THE CORPORATION OF THE CITY OF MARKHAM

Addendum #1

**Bid Opportunity: 091-T-24 - MARKHAM VILLAGE COMMUNITY CENTRE ICE
PAD REPLACEMENT**

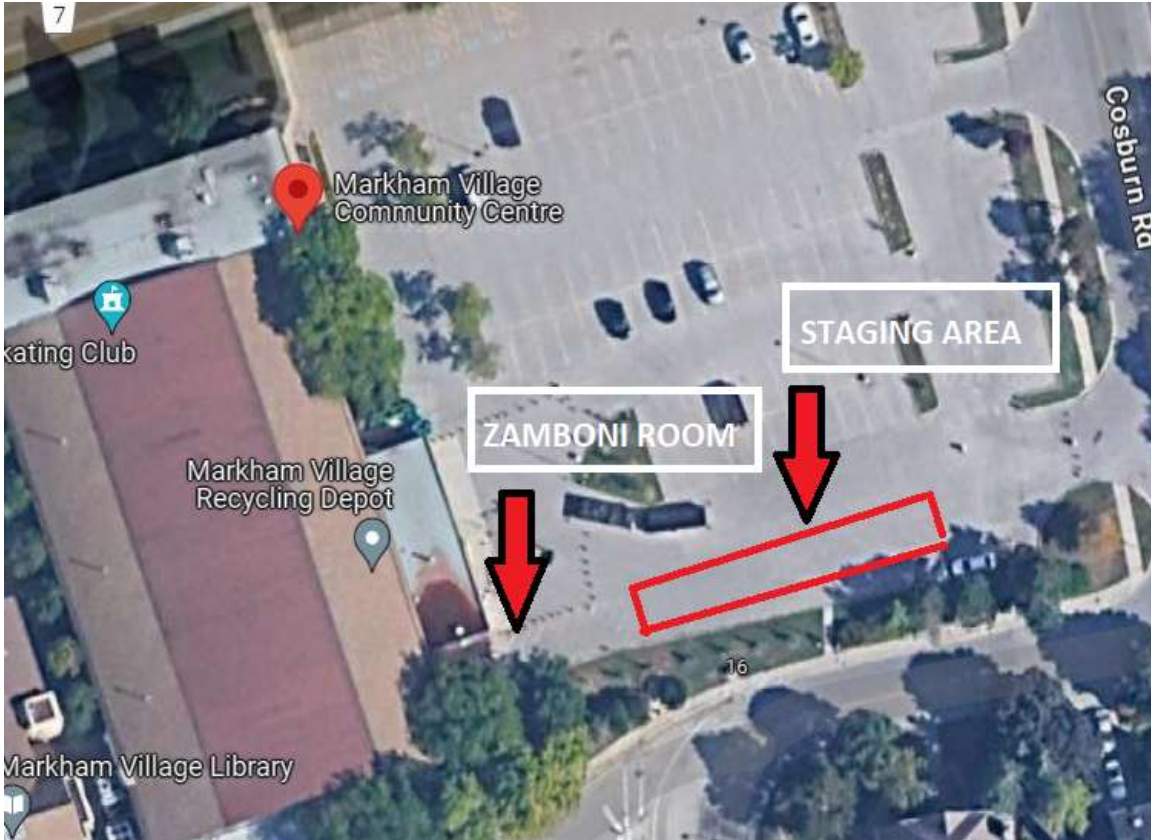
Please confirm type, colour, and height of existing netting as it was not in place during the site visit.

Refer to photo below. The extent of the netting, both existing and proposed is indicated on the drawings.

The existing netting is clear filament.

DATE APRIL 2024	DRAWN BY T.W.	DRAWING No. SK-01
PROJECT No. 24022	CHECKED BY H.A.P.H.

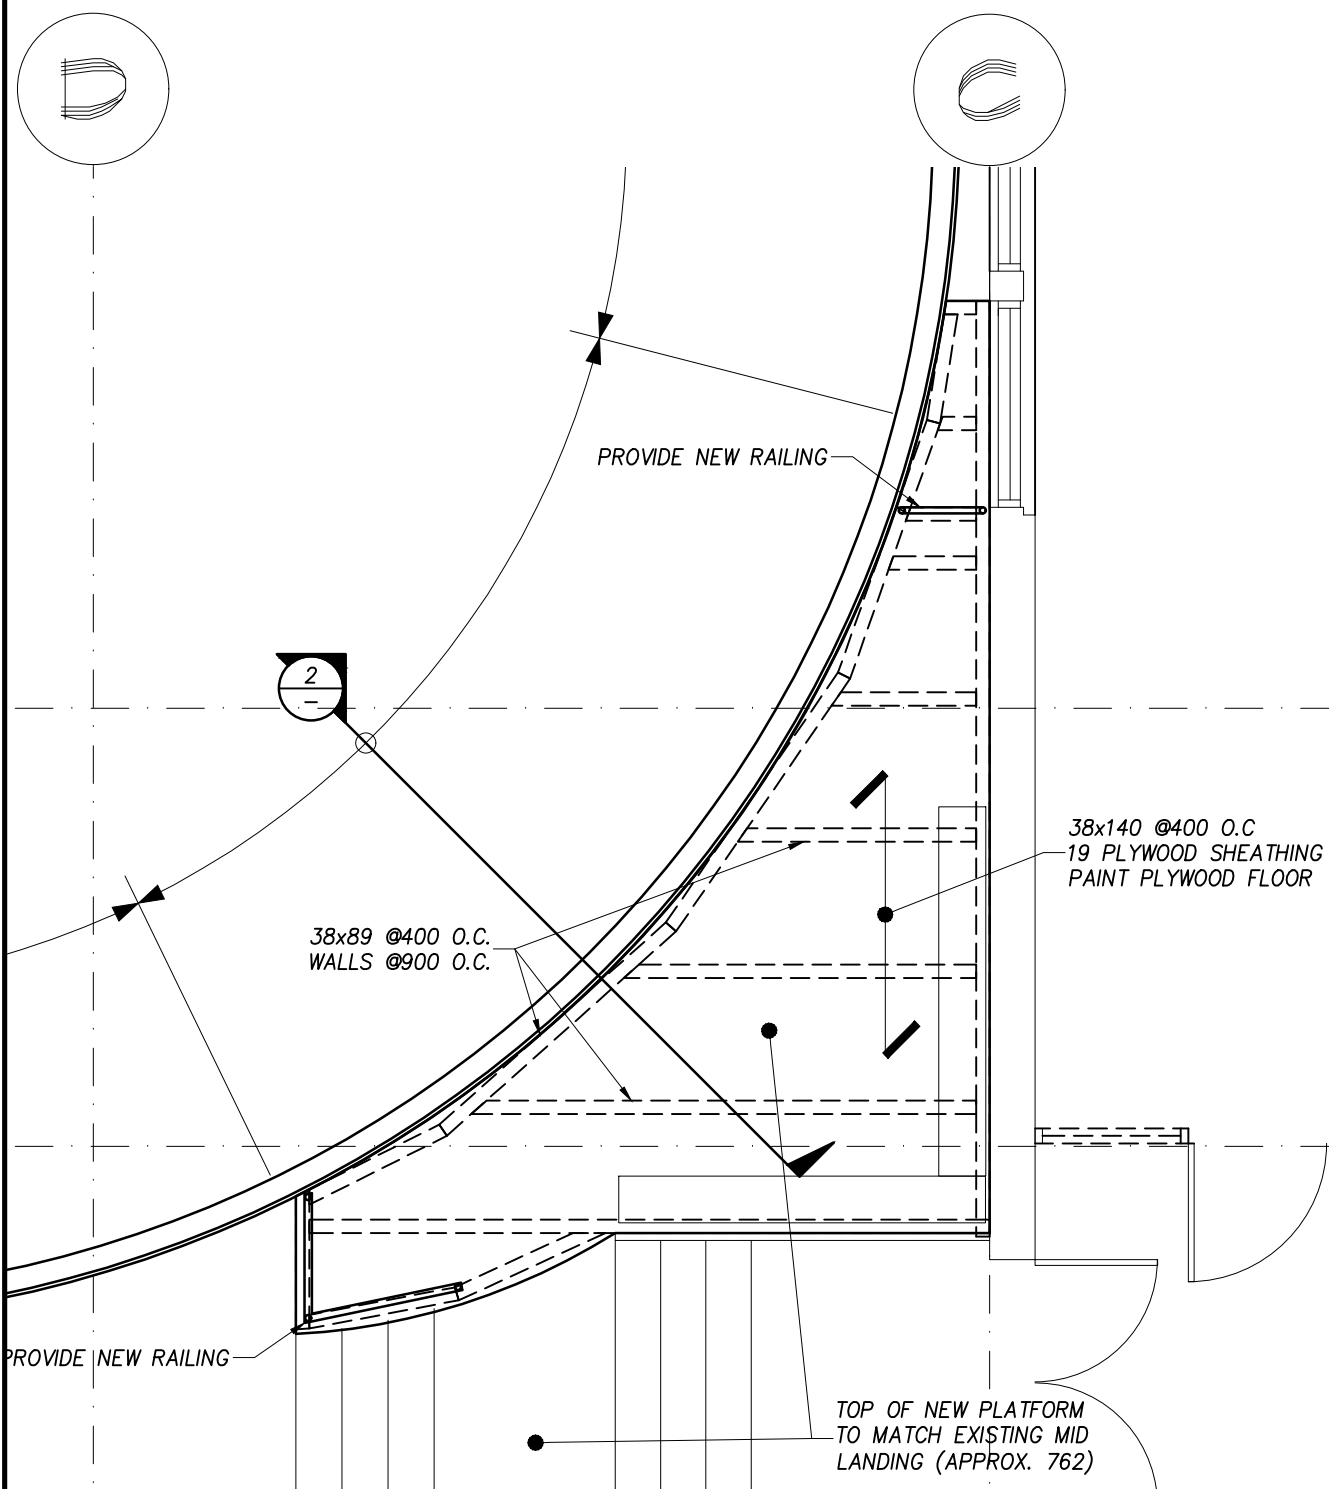
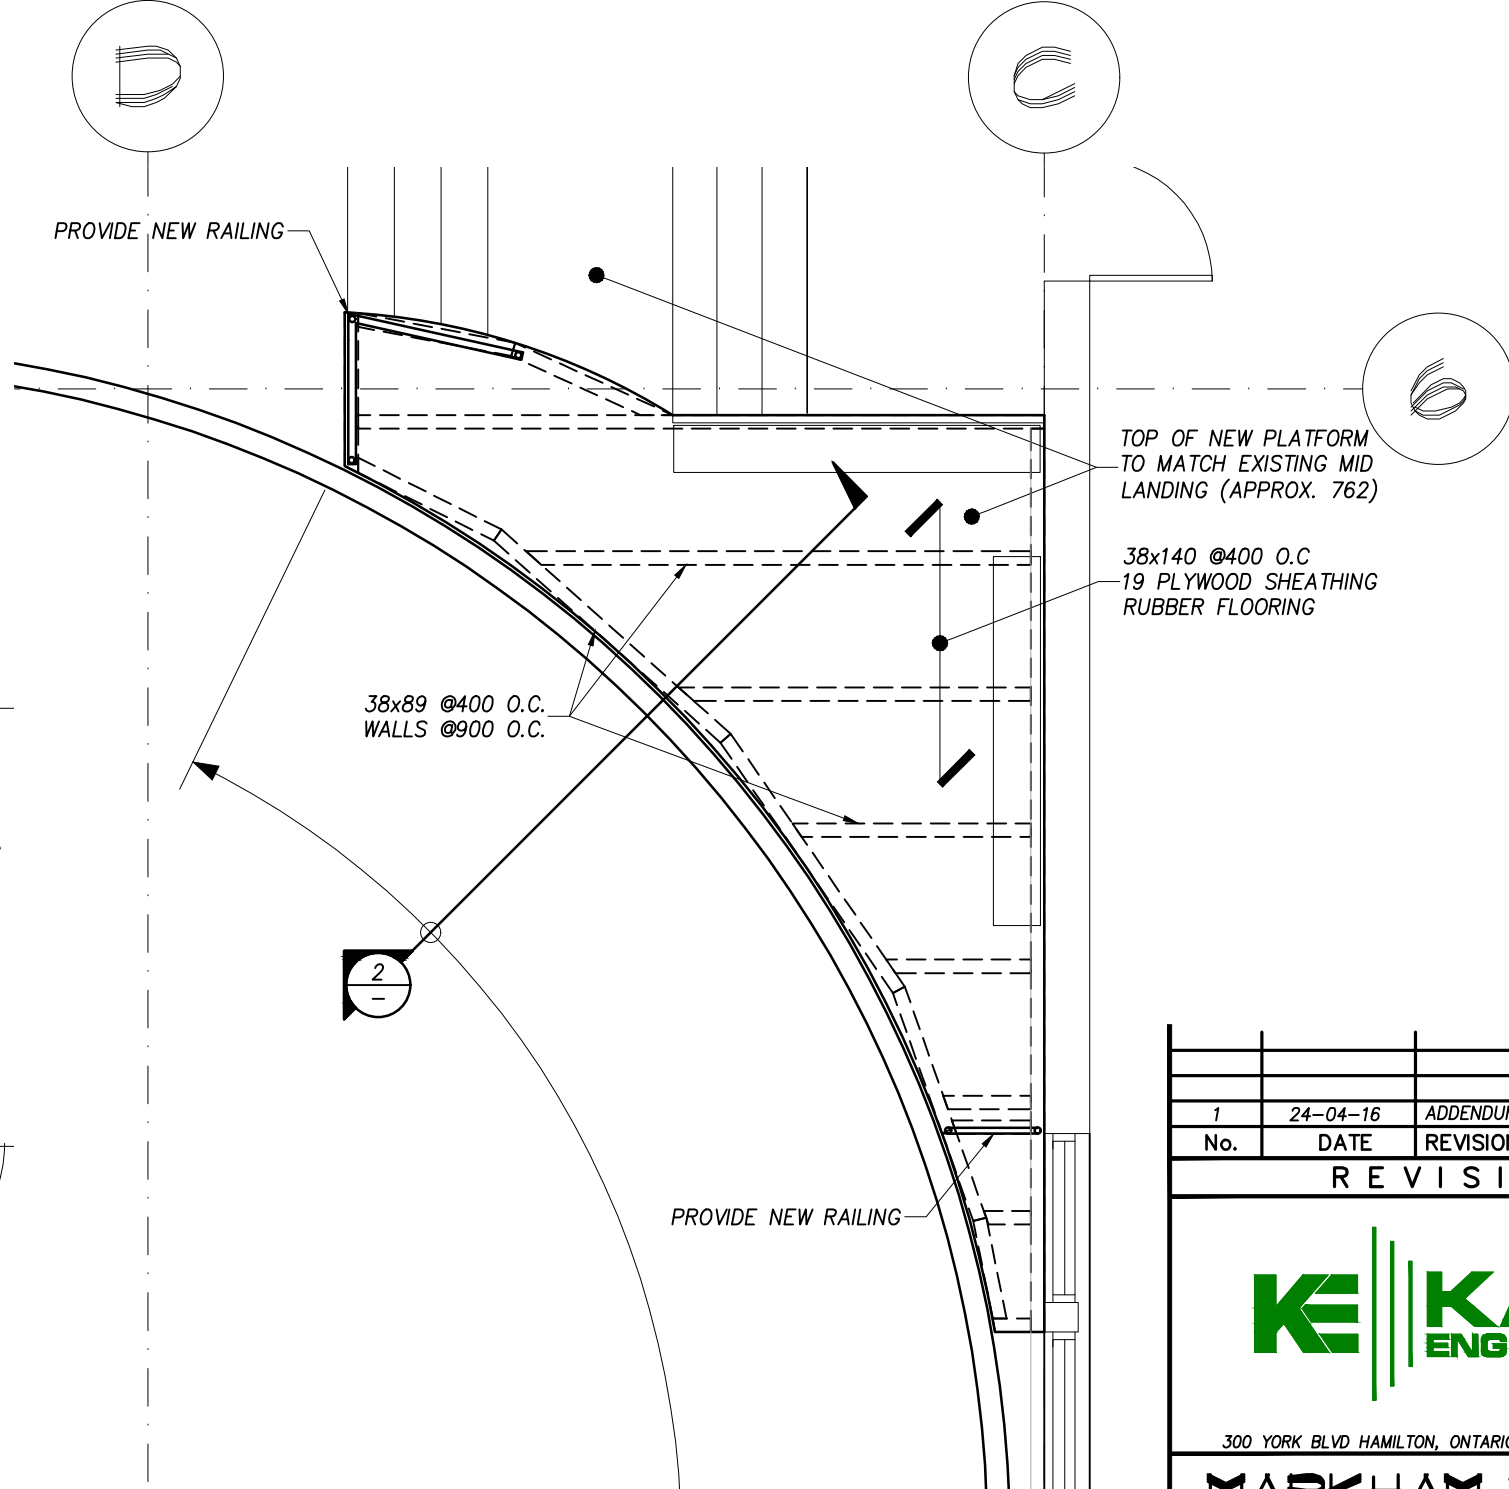
Please provide more details on the guardrails that are required on the new platforms. Are they required to be painted? Is the existing guard rail at the corners of the platform to be removed/replaced or can these be reused on the new platform?

The railing on the upper level (in the concrete can remain (to be painted). The new railing at each end is 38mm posts with 12dia pickets at 100c/c (see attached sketches SK-01 and SK-02). All rails to be primed and painted.
